From: Selim <Selim@sawayaeng.com>
Sent time: 06/18/2019 08:02:35 AM
To: Ron Dragoo
Cc: So Kim; Jill Martin <jmartin@trumpnational.com>; Ara Mihranian; Scott Campbell <scampbell@trumpnational.com>
Subject: 2019-06-18 # Tract 50666 # Request for Storm Drain Amendment
Attachments: 2019-06-17 SD Request2City.pdf

Re: **Request to use Forestall Canyon to convey off-site storm water in lieu of the proposed 60 inch Reinforced Concrete Pipe.**

EXHIBIT "A"
TRACT 50666
PRE-DEVELOPMENT
EXISTING STORM DRAIN

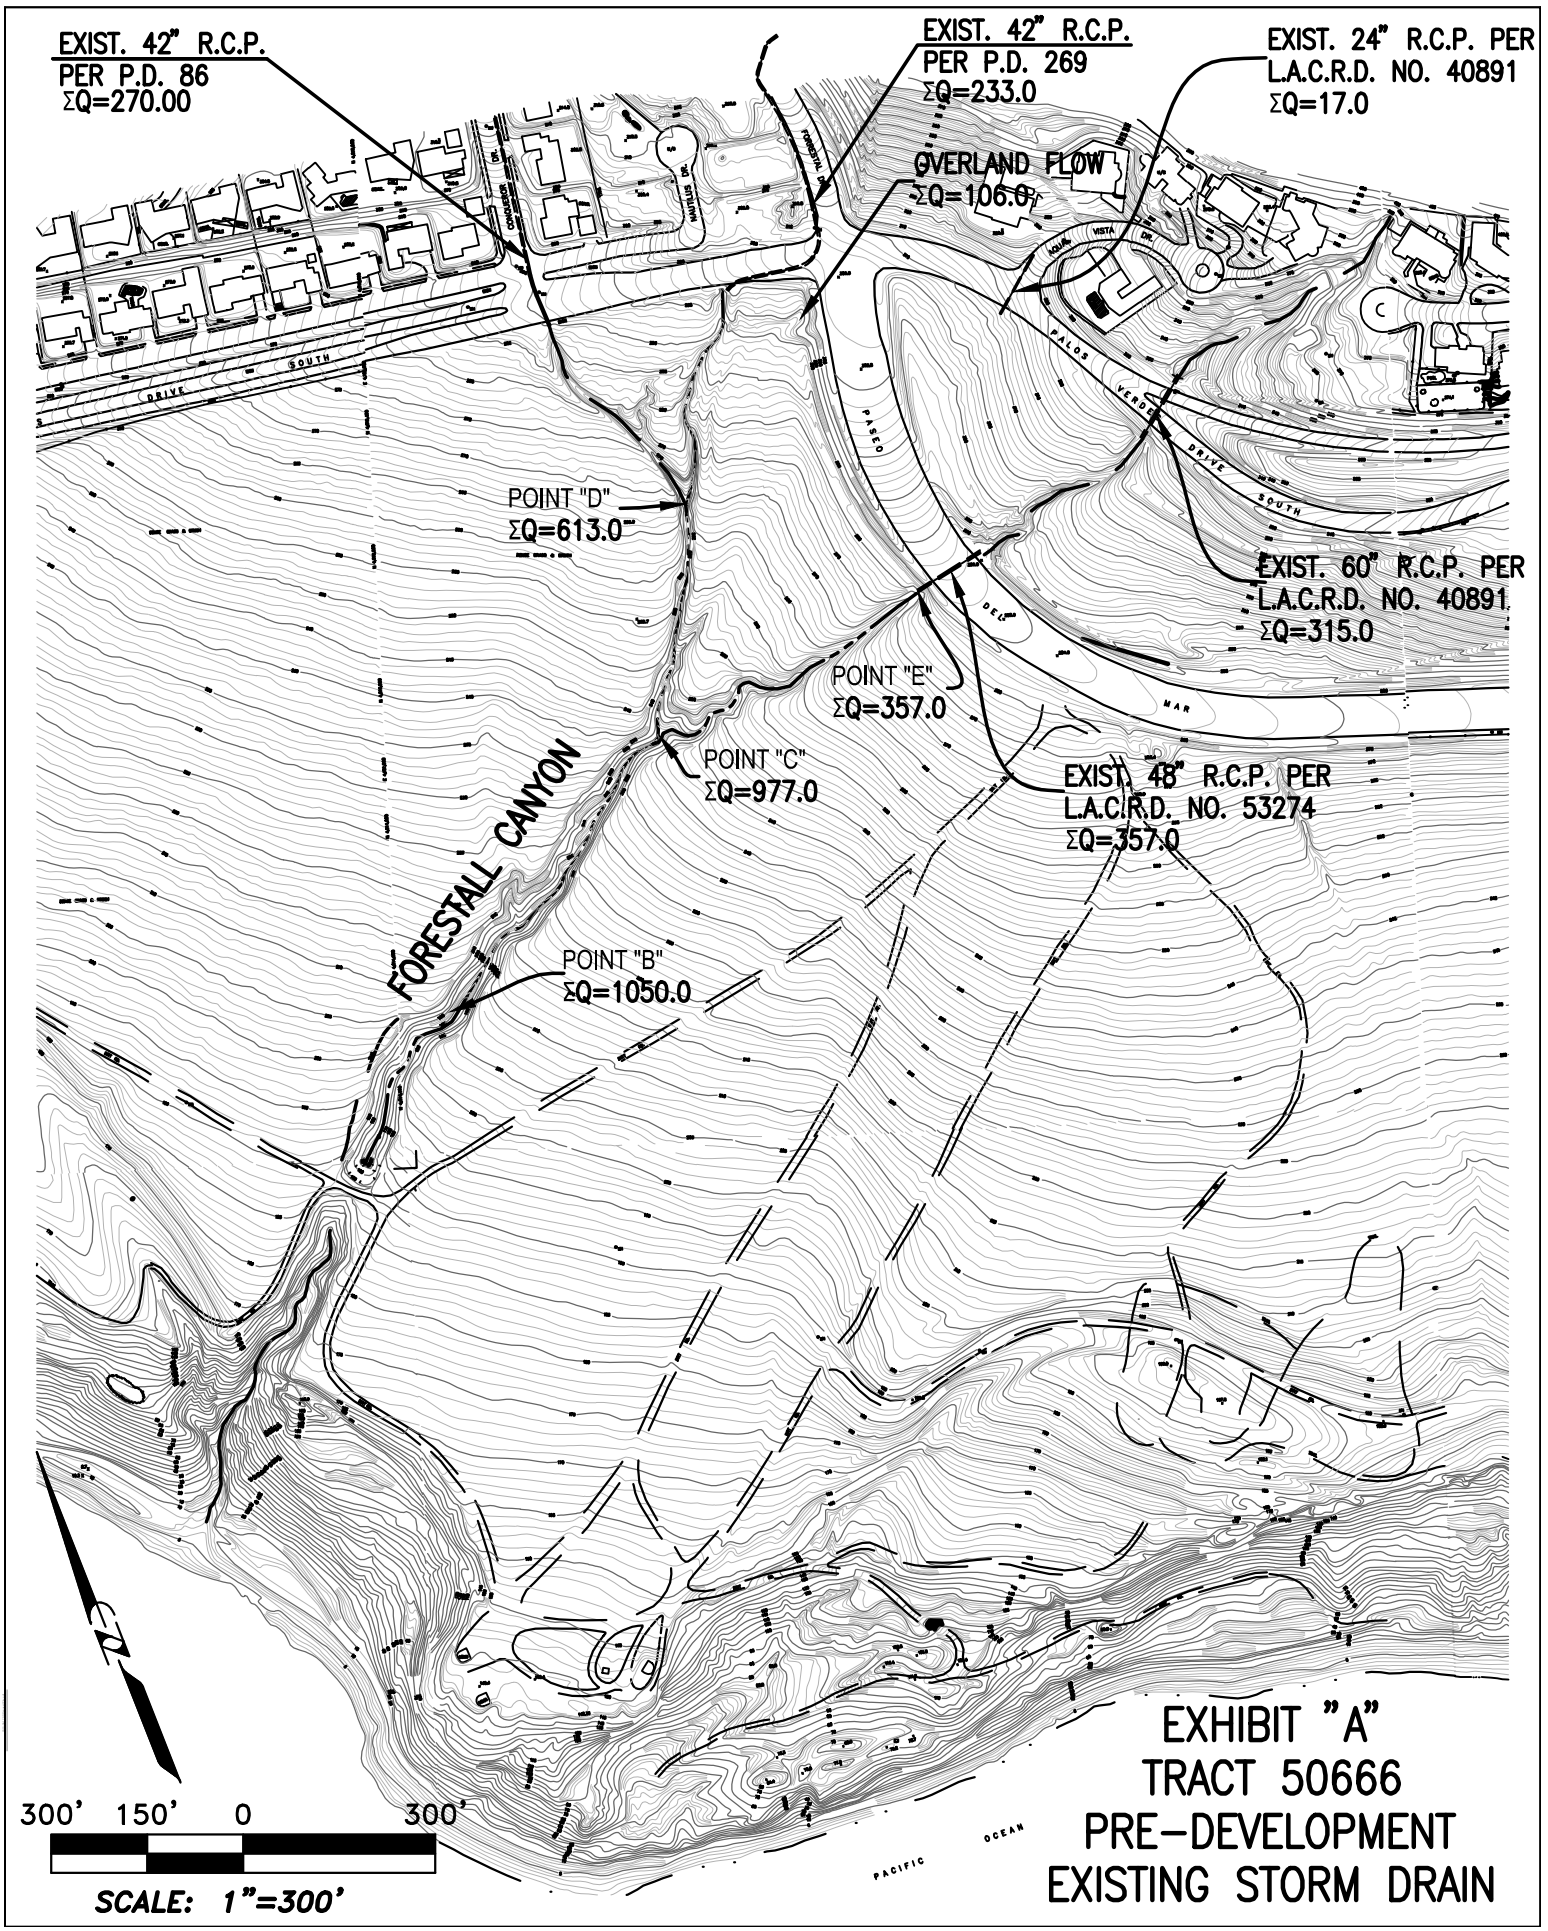
Three different storm drain systems were constructed to outlet to Forestall Canyon to ultimately convey the off-site flow to the ocean. Historically, the flow in Forestall Canyon ranged from 613.0 cfs at Point "D" to 1050.0 cfs. At Point "B" (see Exhibit A).

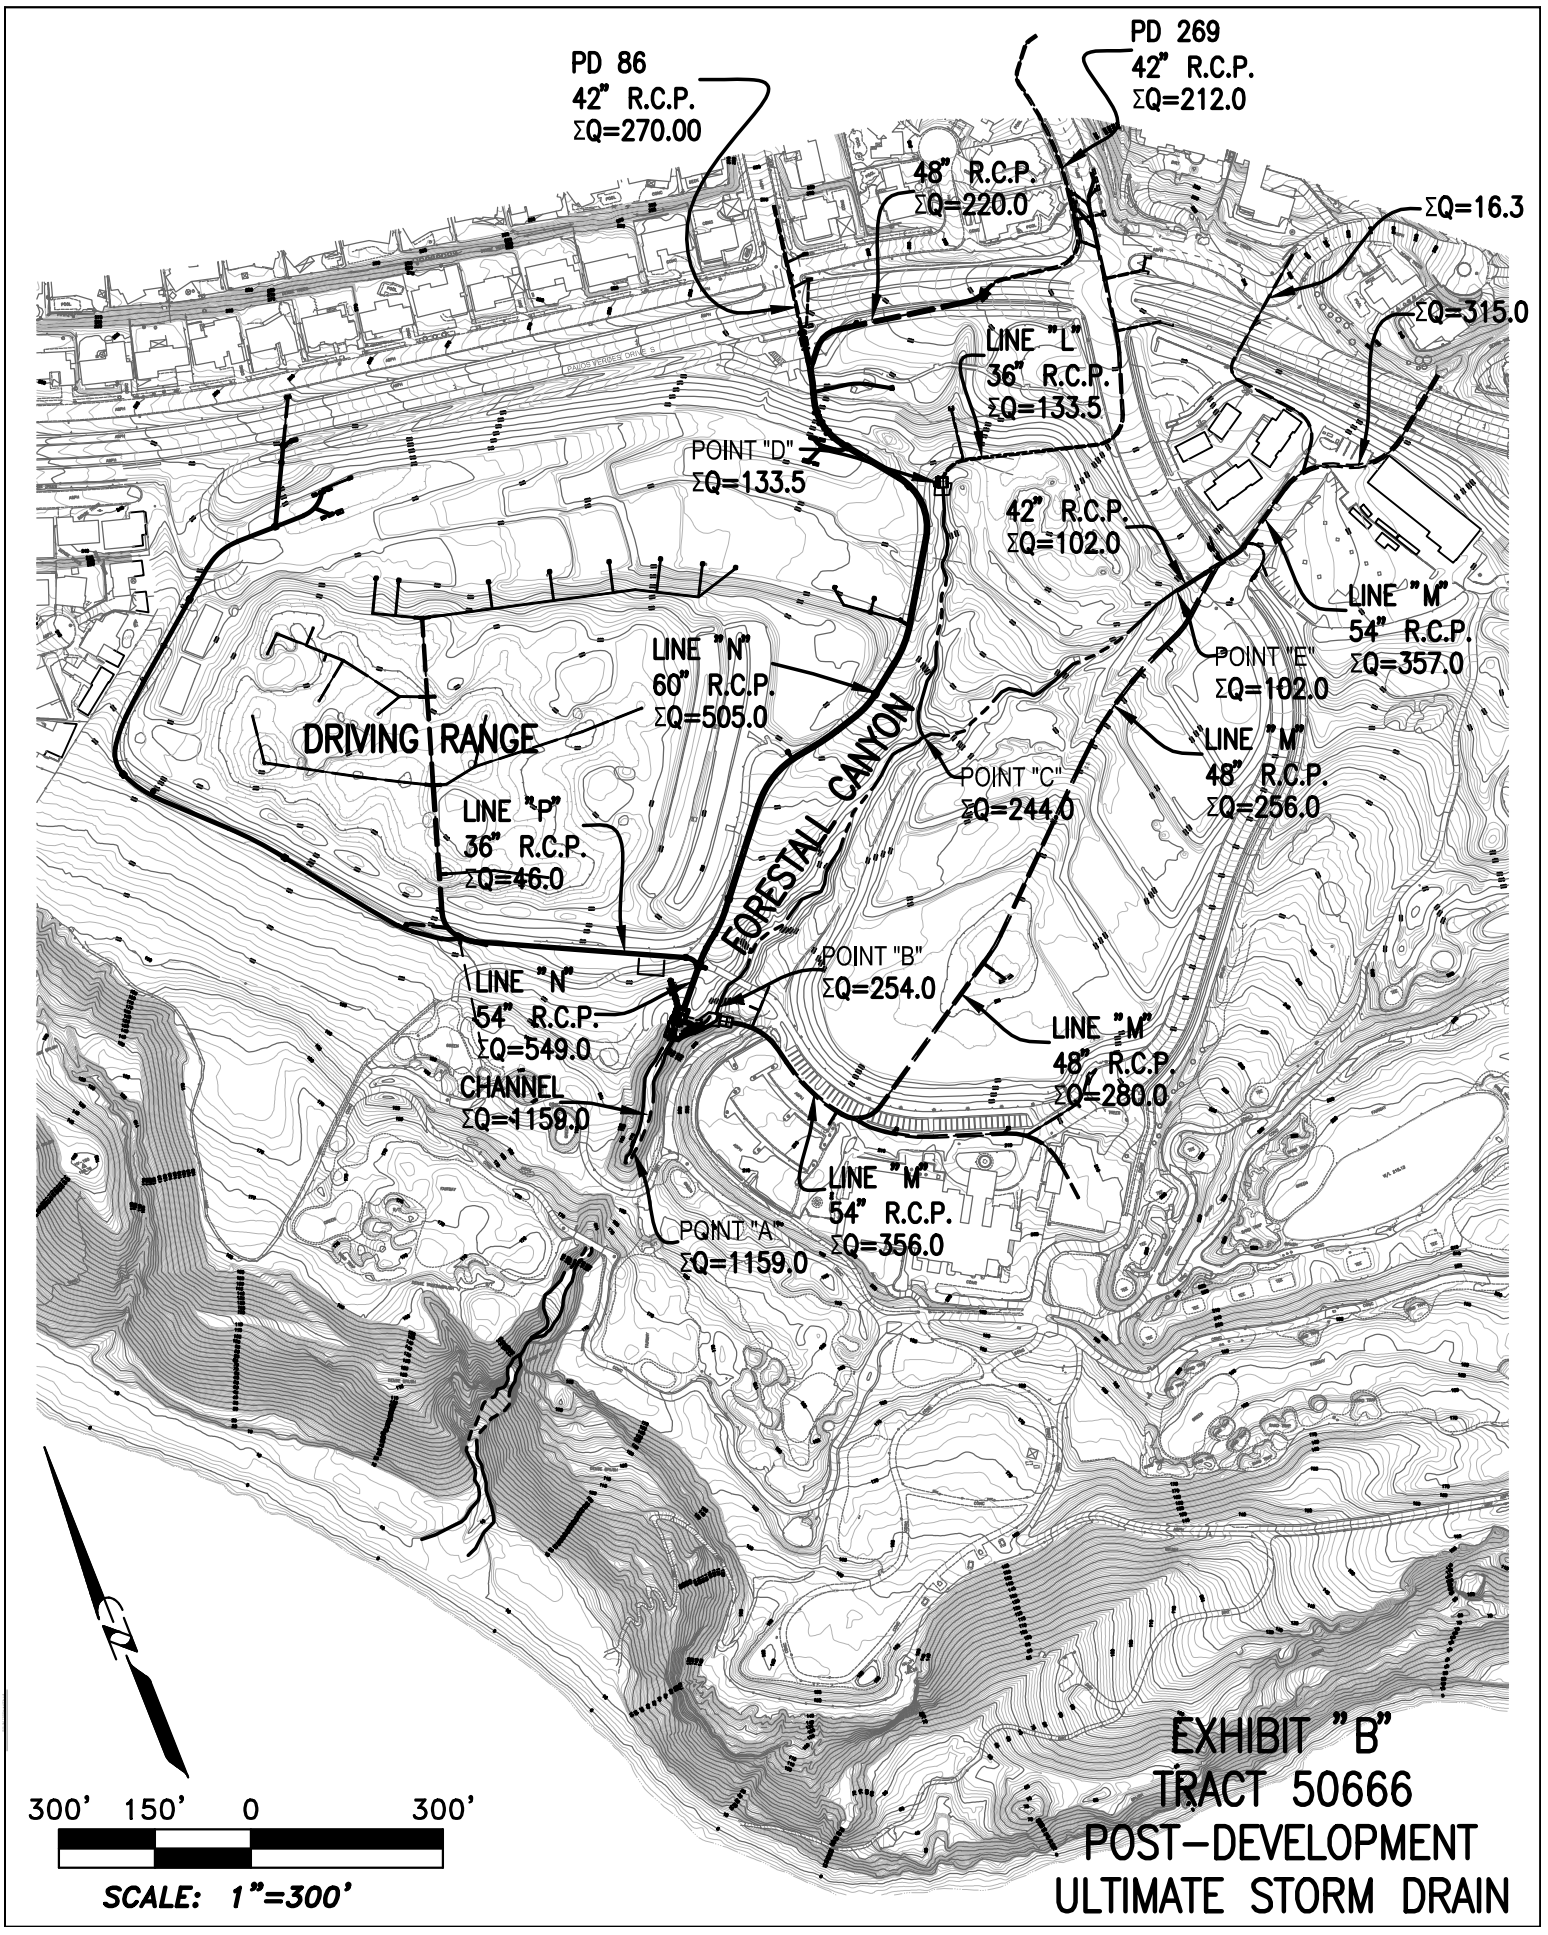
The Drainage Concept of the development as proposed in 2000 and shown on Exhibit "B" was set to reduce / minimize the risk of flooding of the proposed lots from Forestall Canyon. As a result, the flow within Forestall canyon was reduced from 1050.0 cfs at Point "B" to approximately 254.0 cfs. The balance of approximately 800 cfs was to be conveyed back to Forestall Canyon downstream of the proposed lots at Point "B" via a storm drain piping system.

The storm drain systems per PD 86 and PD 269 were existent prior to the development. Line "L" and Line "M" were constructed in 2004 and have been in operation since. The only remaining storm drain lines to be constructed for the development to satisfy the approved Drainage Concept are Line "N" and line "P" (See Exhibit "B").

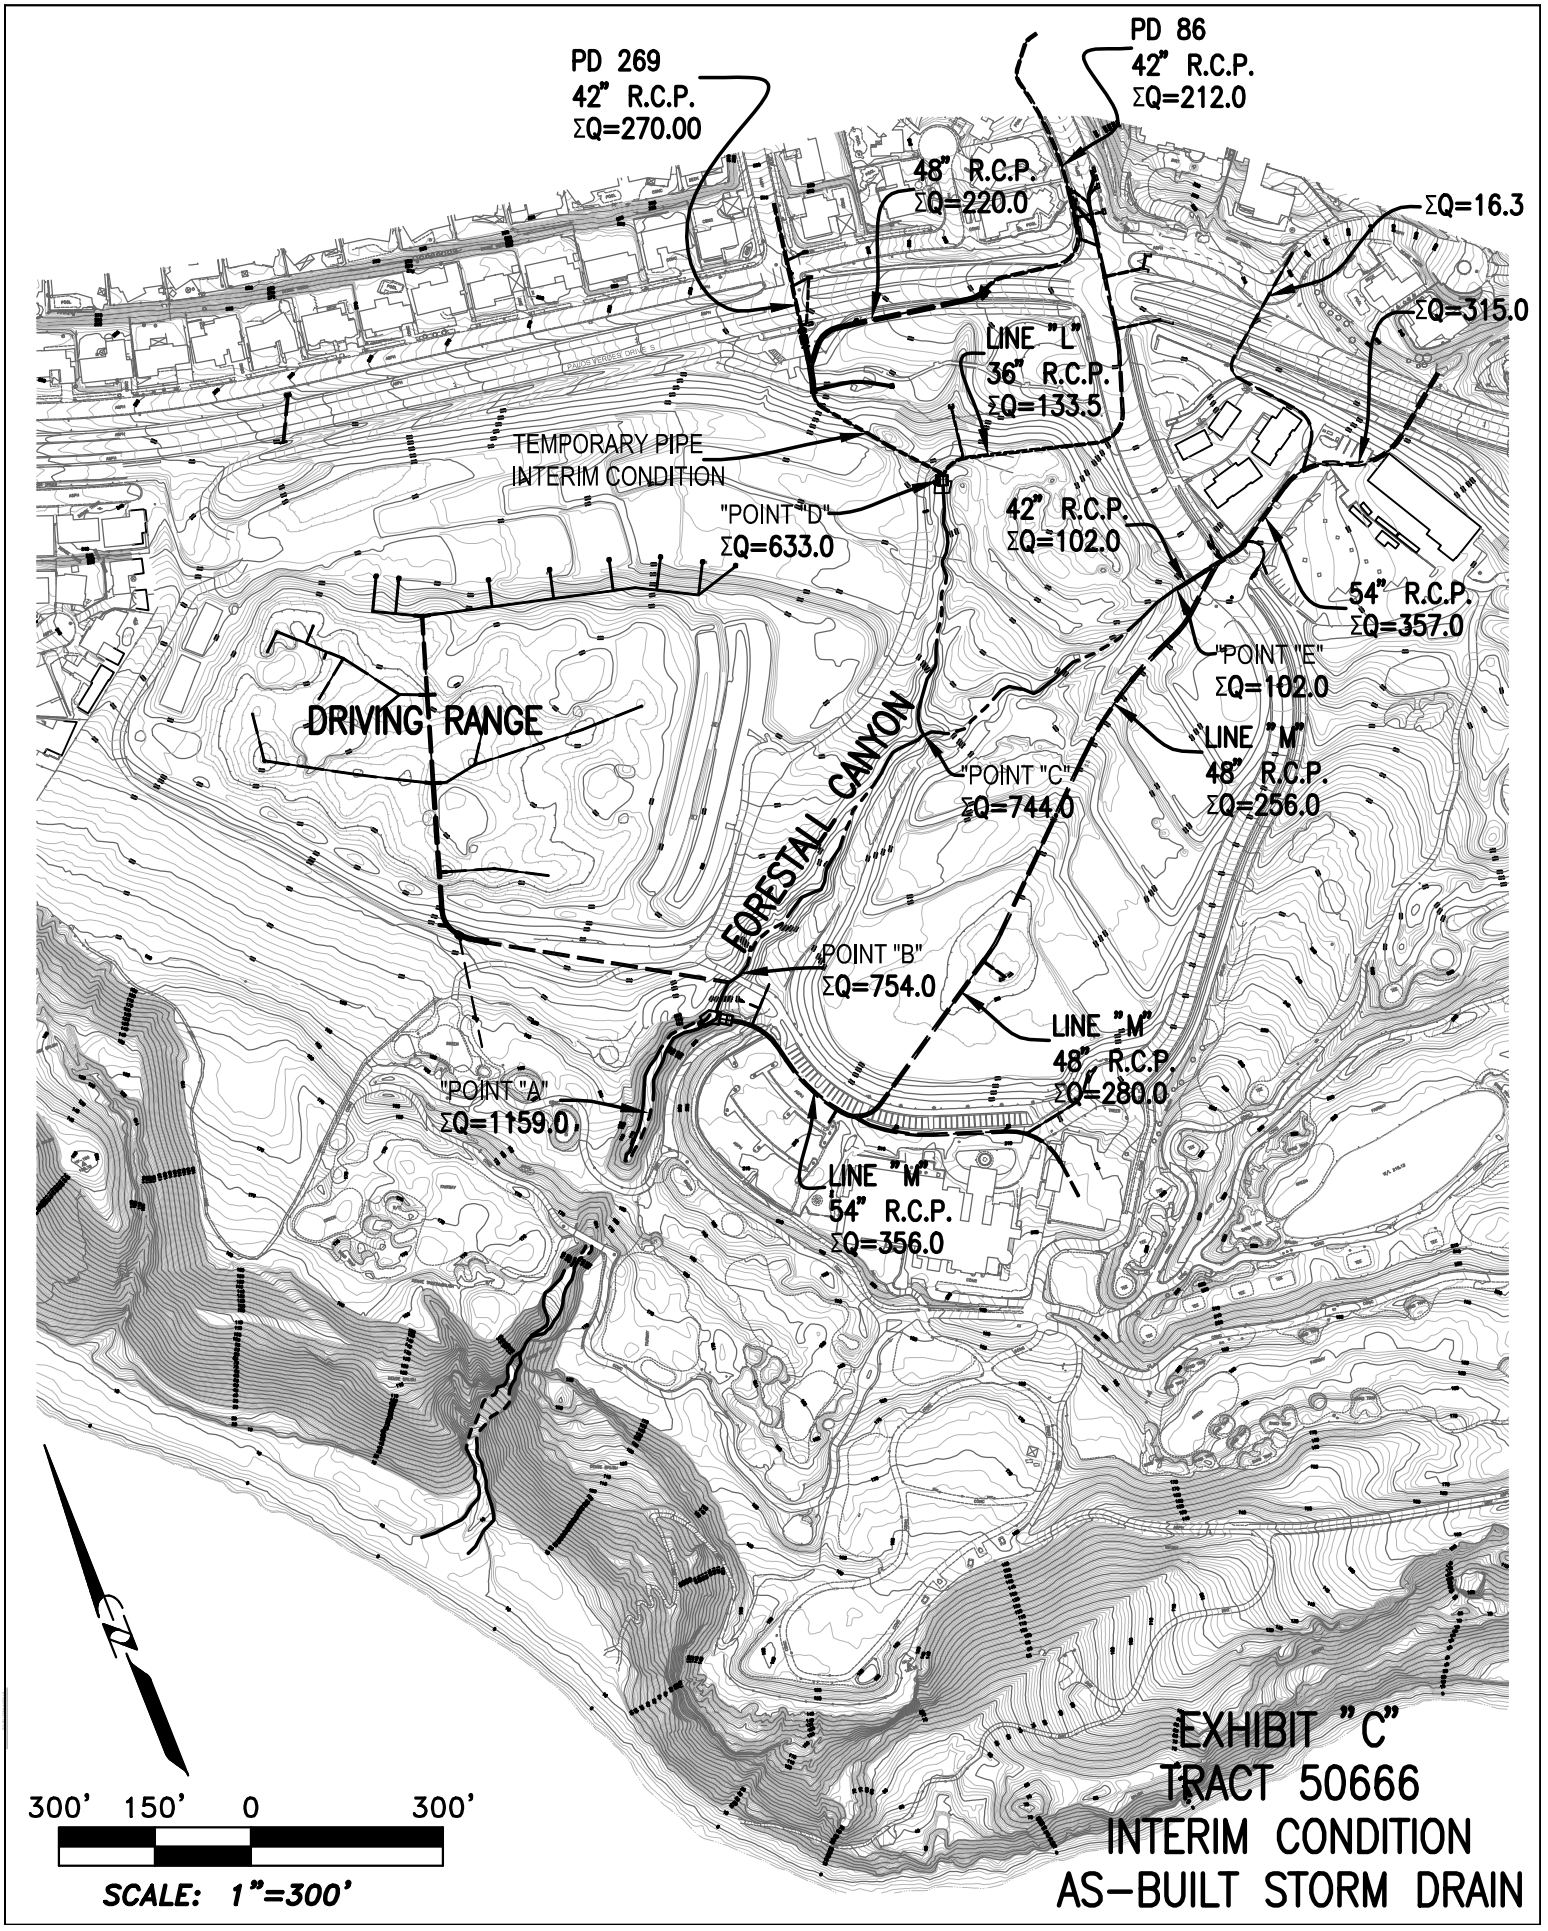
In the interim and until the ultimate drainage system is completed, a temporary pipe was constructed in 2005 to convey the flow of PD 86 and PD 269 back to Forestall Canyon (See Exhibit "C"). Since 2005, (approximately 15 years), the flow within Forestall Canyon between Point "D" and Point "B" has ranged from 633.0 cfs to 754.0 cfs, which is below the historical / predevelopment flow of 1050.0 cfs.
